# NOTICE OF DECISION

## PLANNING ADMINISTRATOR DECISION FOR SITE PLAN REVIEW

**CASE TYPE:** Class 2 Site Plan Review  
**AMANDA NO.:** 22-106913-RP  
**DATE OF DECISION:** July 7, 2022  
**PROPERTY LOCATION:** 1010 Hawthorne Avenue SE  
**APPLICANT:** Christopher Rutledge, Parkway C&A, on behalf of owner, Costco Wholesale Corporation, and purchaser Dickerhof Properties LLC (Darren Dickerhof)  
**REPRESENTATIVE:** Rhine-Cross Group, LLC  
**ZONE:** CR (Retail Commercial)  
**COMPREHENSIVE PLAN:** COM (Commercial)  
**OVERLAY:** None

**SUBJECT:** PUBLIC WORKS RECOMMENDATIONS  
CLASS 2 SITE PLAN REVIEW (22-106913)  
1010 HAWTHORNE AVENUE SE  
TENANT IMPROVEMENTS

Overall  
Siteplan

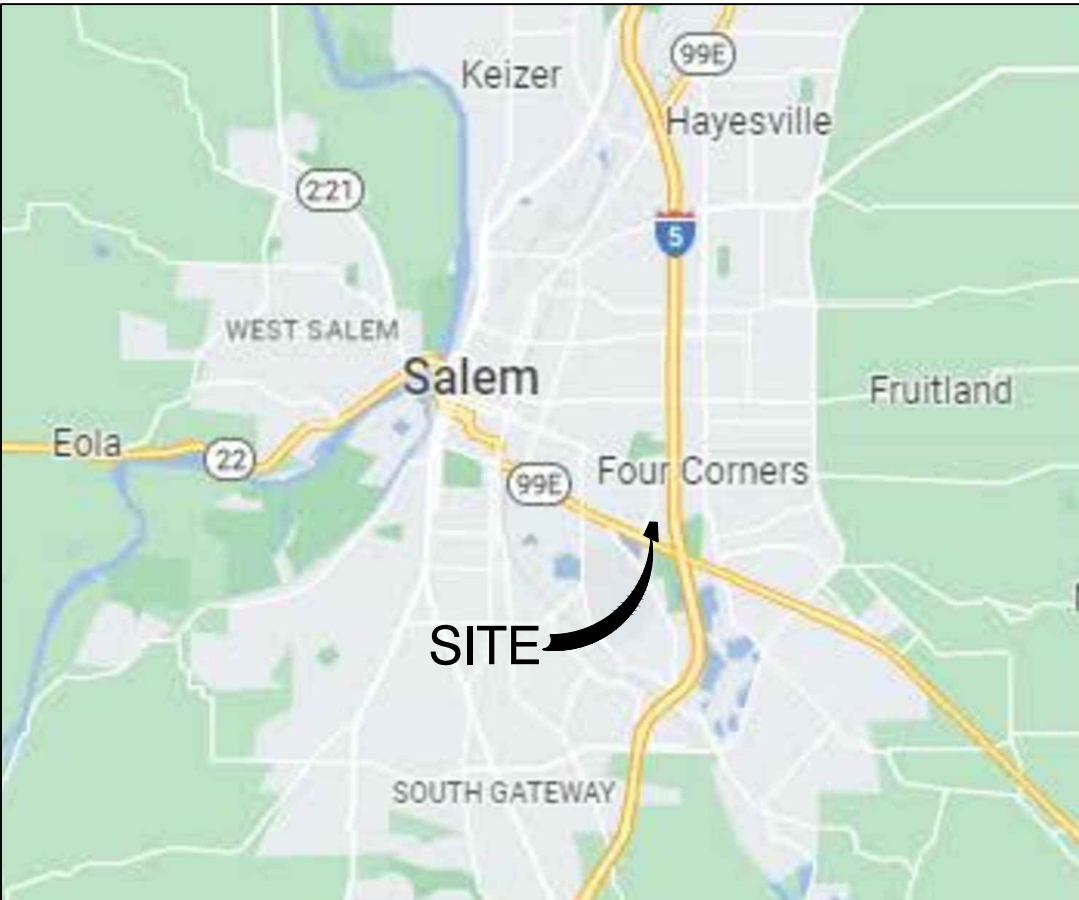
**Finding:** The site plan indicates an existing pedestrian connection to Hawthorne Avenue SE that will be retained and two proposed pedestrian connections to Mission Street SE. The proposal meets the standard.

**Finding:** The site plan indicates that the parking area south of the building is over 170,000 square feet in area and approximately 575 feet wide, with 10 drive aisles. The minimum requirement is two pedestrian connections ( $10 / 4 = 2.5$ , rounded down to the 2). The proposal includes two proposed pedestrian connections to Mission Street SE. The proposal meets the standard.

**Finding:** The site plan indicates a vehicular connection to the abutting property to the north, which is occupied by a hotel. The site plan indicates a pedestrian connection to the north property line. The proposal meets the standard.

**Finding:** The site plan indicates that the three proposed pedestrian connections will be five feet wide concrete sidewalks cut into asphalt at grade. Wheel stops are indicated to prevent encroachment of vehicles from head-in parking spaces. The proposal meets the standards.

**Finding:** For the existing building of 143,260 square feet, the minimum requirement is 573 spaces ( $143,260/250 = 573.04$ ). The applicant's site plan indicates 585 spaces, exceeding the minimum requirement and meeting the standard.

**Finding:** Existing parking spaces are being reconfigured to accommodate the proposed pedestrian connections. Several ADA spaces near the southwest corner of the building are being removed to create ramps for the pedestrian connections. Spaces in the rows within the parking area are being reconfigured so that the pedestrian connections may be constructed and ADA parking spaces may be relocated. The reconfigured parking spaces conform with the minimum dimensions of Table 806-6 and meet the standard.
